Buildings- Old College site, Nungambakam - Construction of
residences for officers - deferred.

Sub:- Old College park - survey of the --- showing
the lay-out for constructing 3 bungalows. *p2ante*

Office of Director of Public Instruction
Compound showing the Proposed
quarters

No. C.A. 127/1919

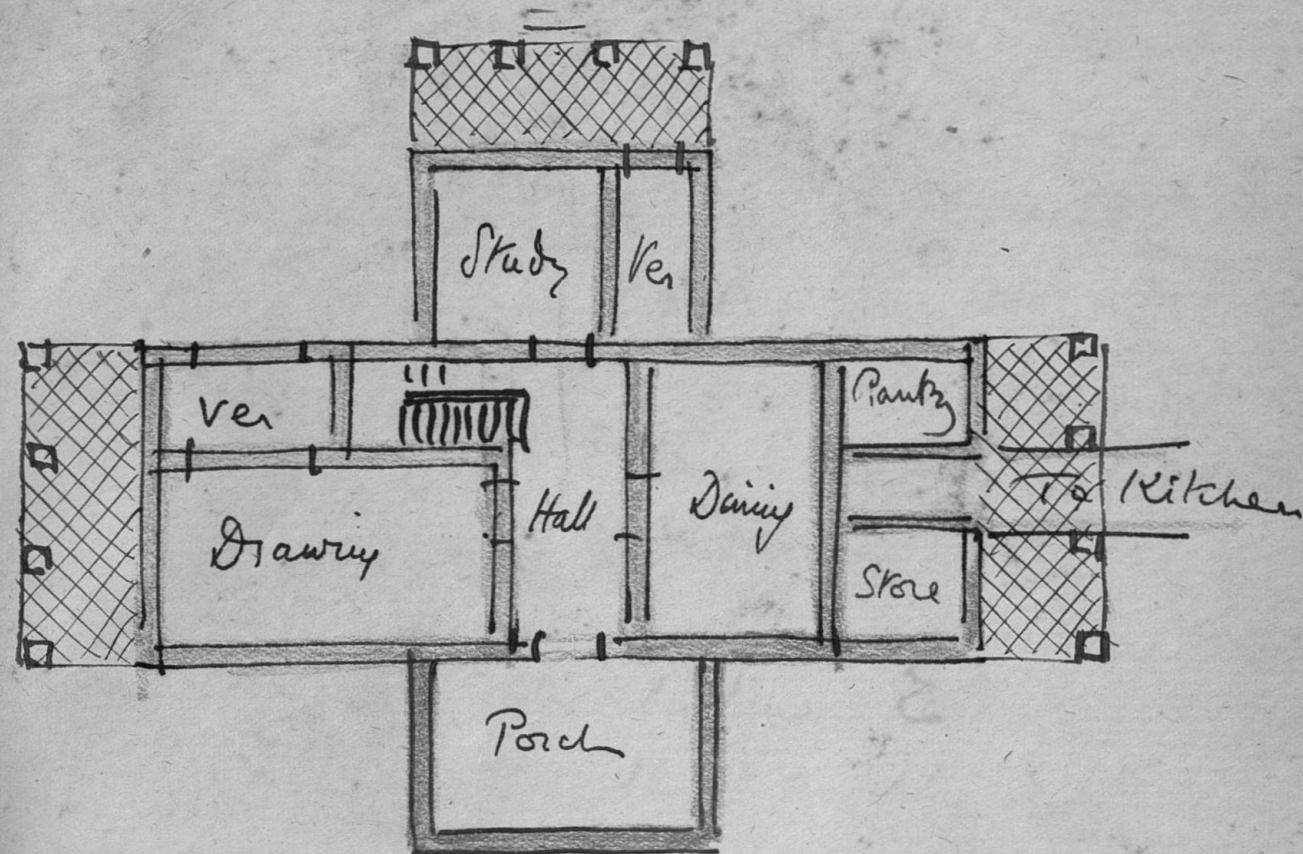
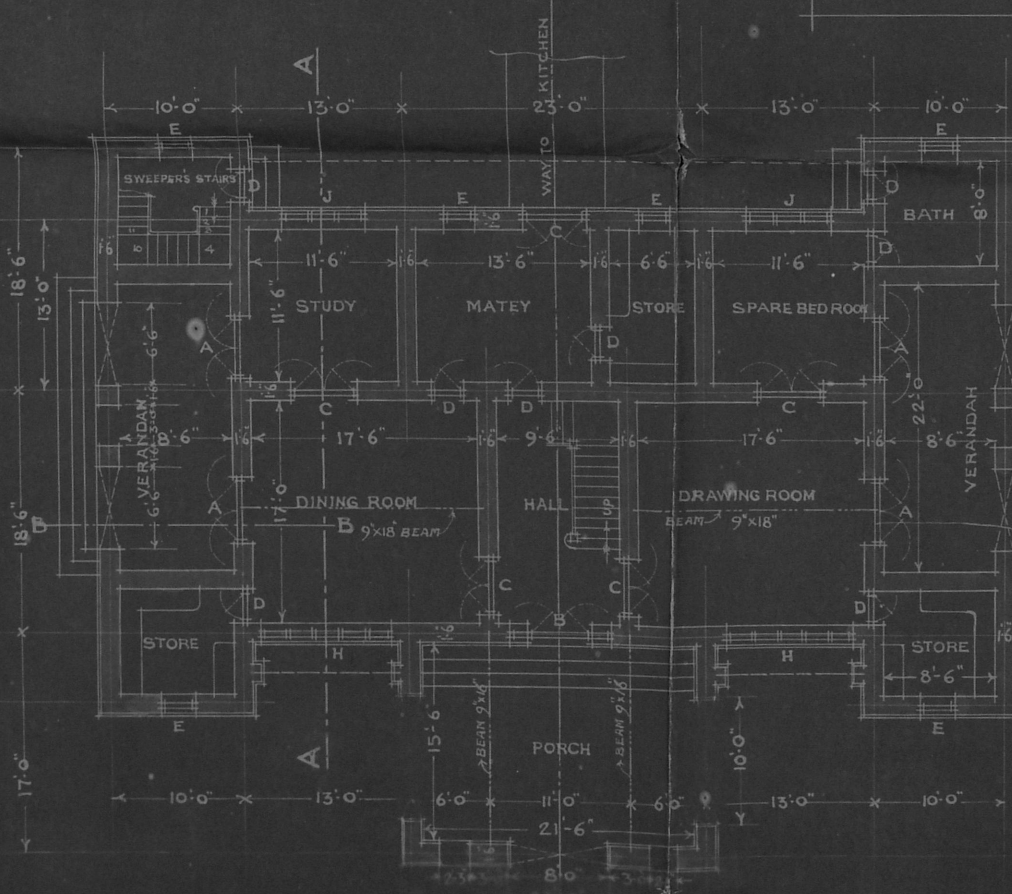
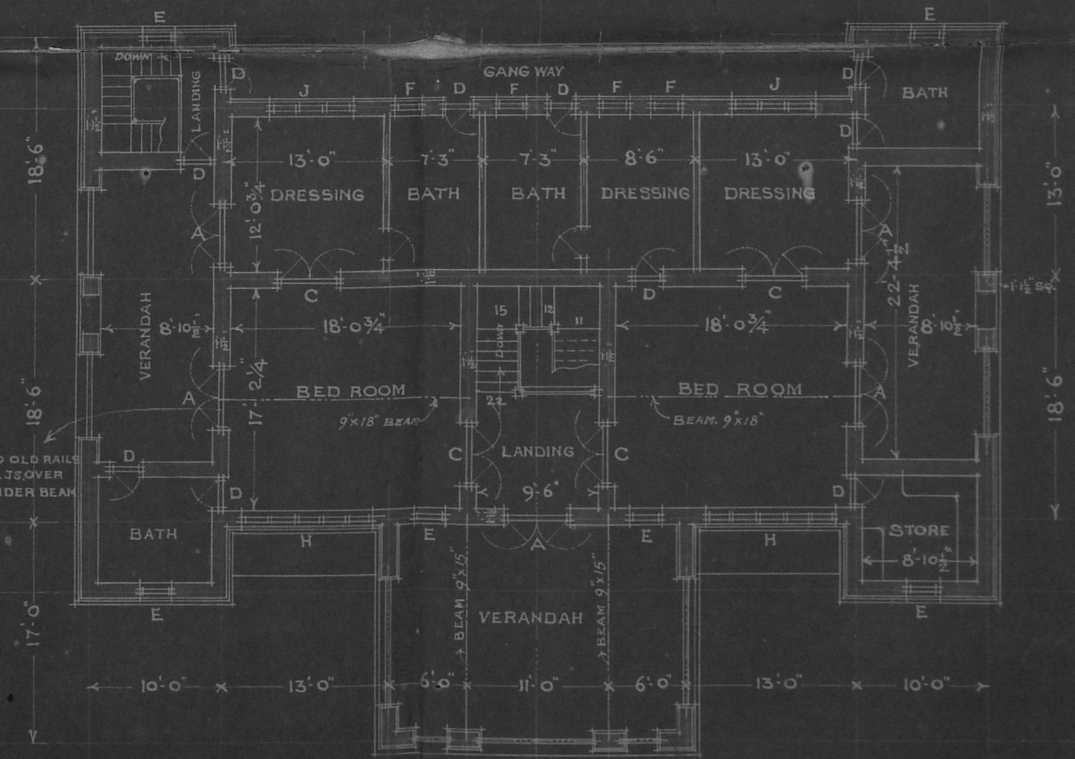
The approximate cost of CA 127/19 would be
 main building Rs 30.00
 Outhouses etc 8.00

This was the design selected by Dr Beaton.

Nº C.A. $\frac{117}{1919}$

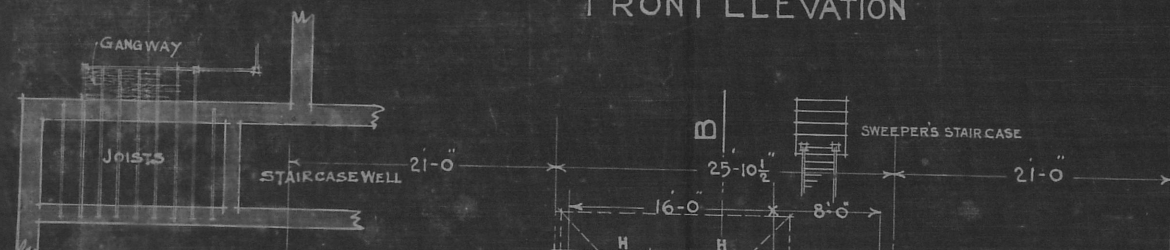
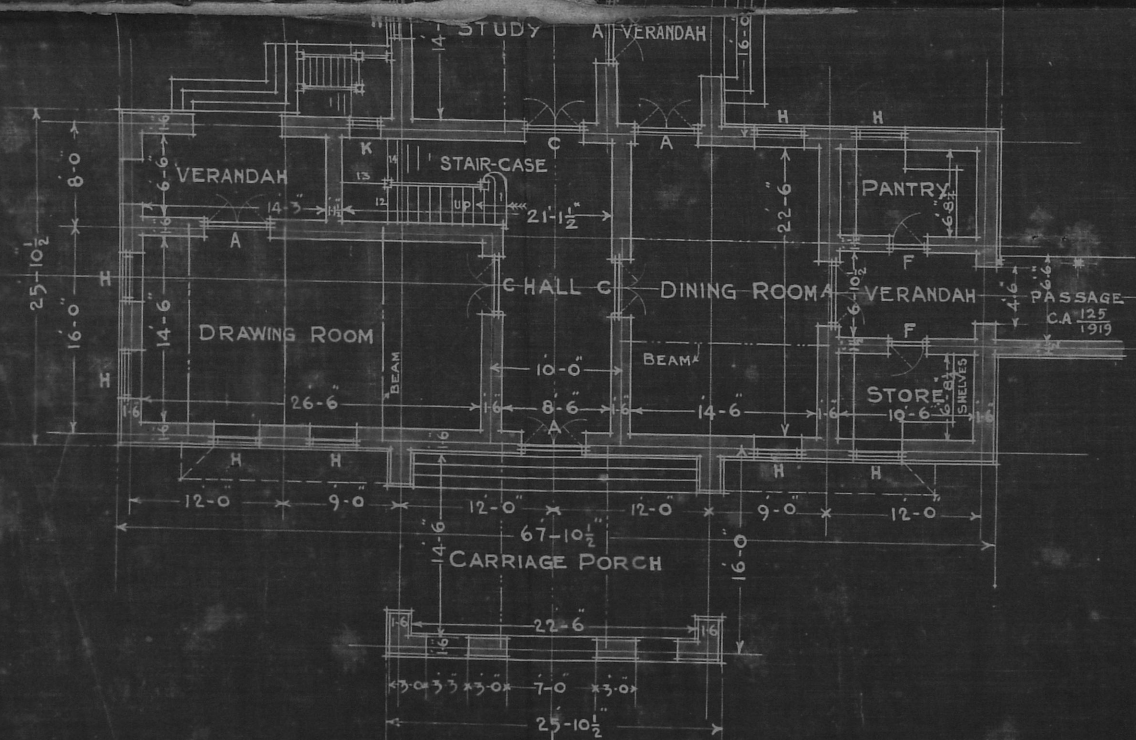
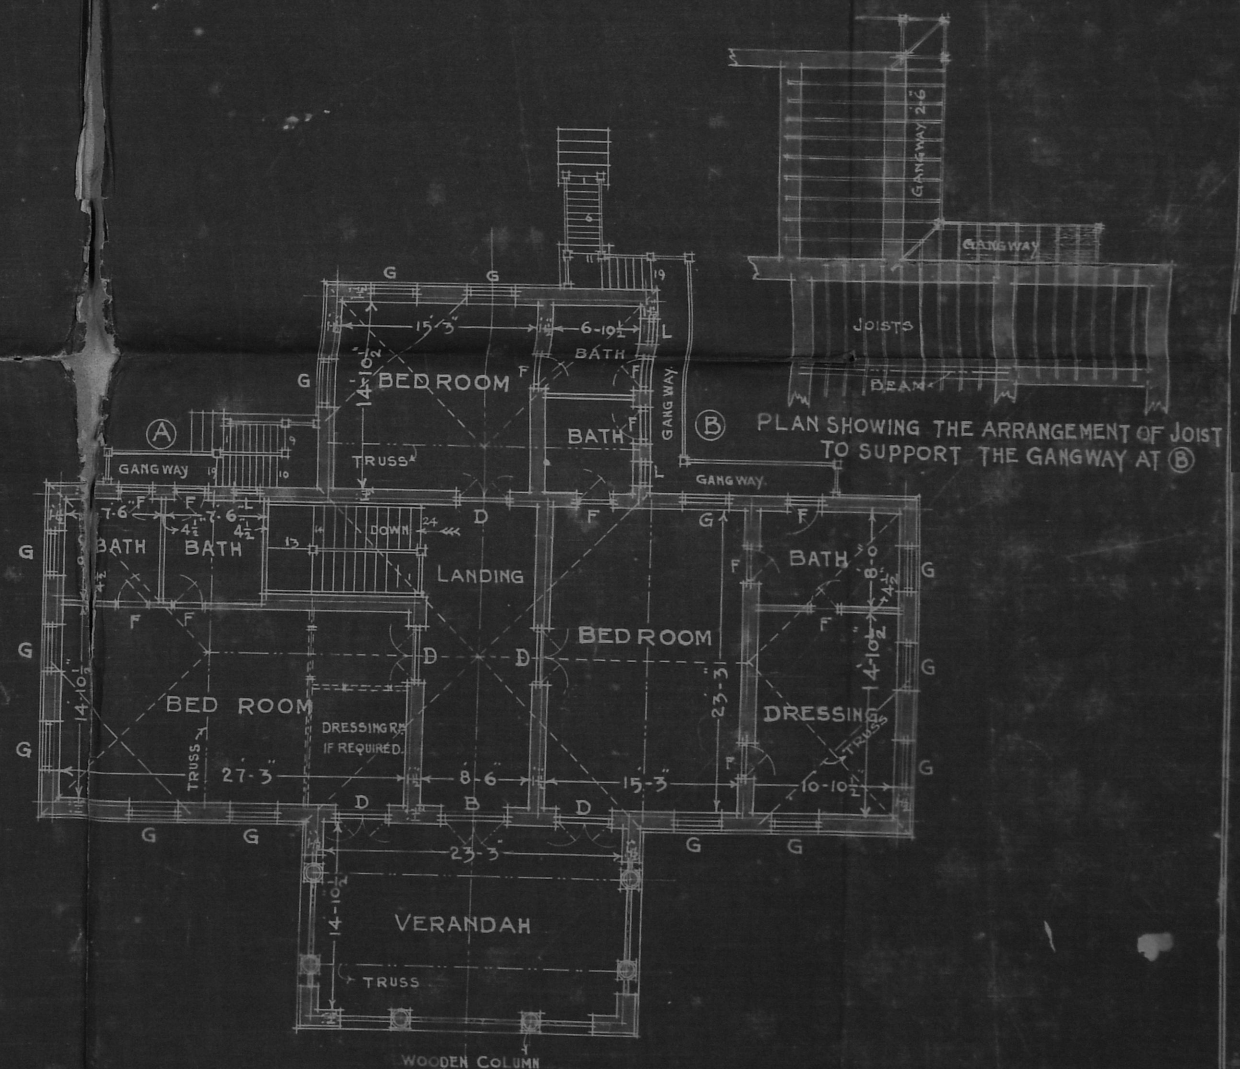
Refer to CA 117/19.

The addition of verandahs ^{on both floors} as indicated in red would cost approximately Rs 6000 in addition.

Roof can be terraced throughout.

Note - A terraced roof could
easily be designed for a
plan of this kind.

P.S. No 47
1923

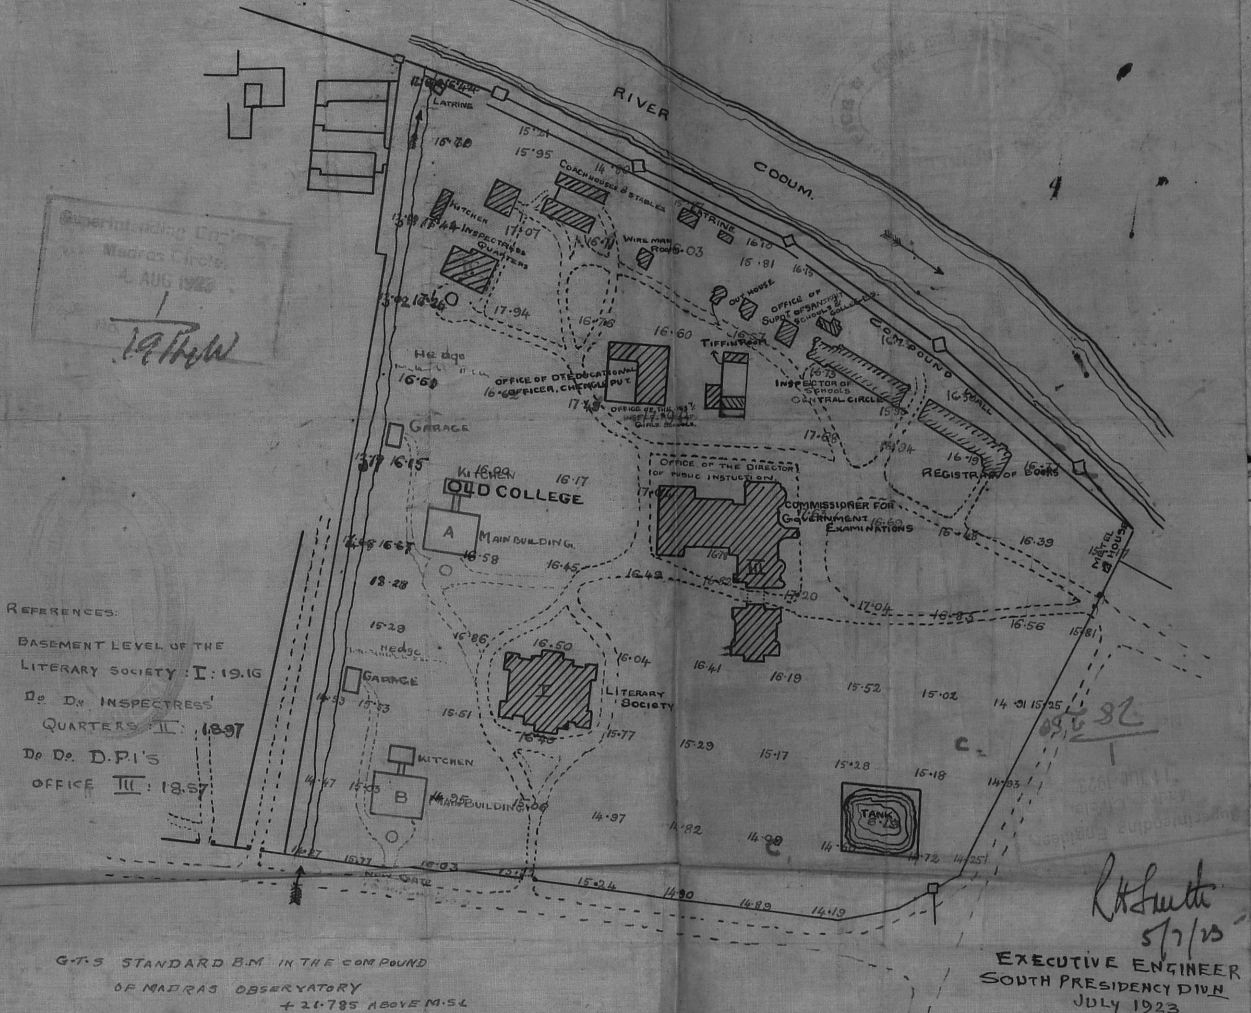
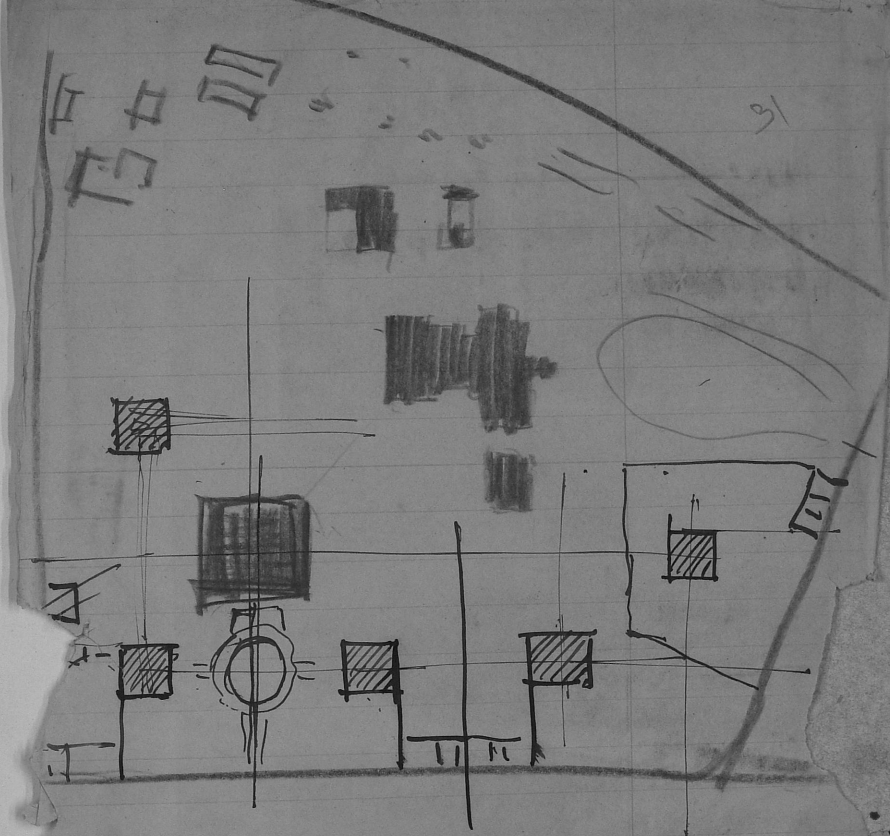
The survey should have been drawn to a larger
scale and the spot levels marked on it.

P.W. D memo 492 Who
B The tracing P.S. No 47/23
forwarded by the S.E. is
returned to him for re-
-submission after marking
the spot levels on it.

is rather small for the purpose of a layout. It is possible for you to prepare a site plan about 4 times as big, showing best of the trees in the S. half of the compound and figuring their stems with reference to ~~base lines~~ certain fixed points?

I think it will be best to take the Literary Socy building as the base & fix everything with reference to it. That building will be the chief point in my layout. I should like to know in figures the distances from this building the E.W. and S. boundaries along the axes - please sketch on next page

The position of the tank in SE corner is important.

2384 I have the honour to resubmit herewith the tracing after
having had spot levels marked thereon.

The levels were taken at 100 ft. intervals. The basement
levels of several of the important buildings in the compound are
also noted for information.

Resubmitted with a big site survey as directed
